From: Pegah Fahimian
Sent: Tuesday, July 11, 2023 1:33 PM
To: Katie Anderl
Subject: RE: Recirculation OPA/Zba 130-142 Victoria St

City of Kitchener
Zone Change Comment Form

Address: 130-142 Victoria St S

Application: OPA/ZBA

Sight distance analysis

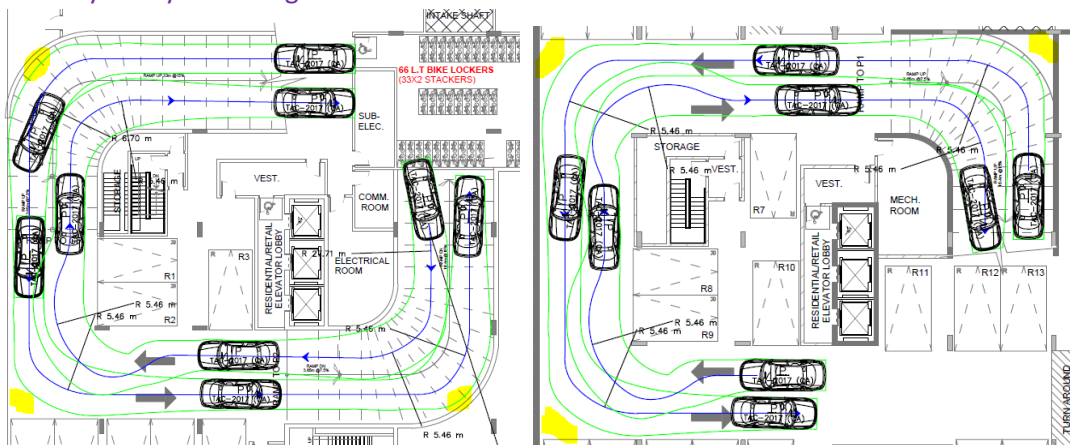
Bramm Street is straight and flat with low vehicle speeds and based on a 50km/h design speed it was determined that there are clear sightlines and visibility is not expected to be a concern. Transportation Services supports Paradigms conclusion.
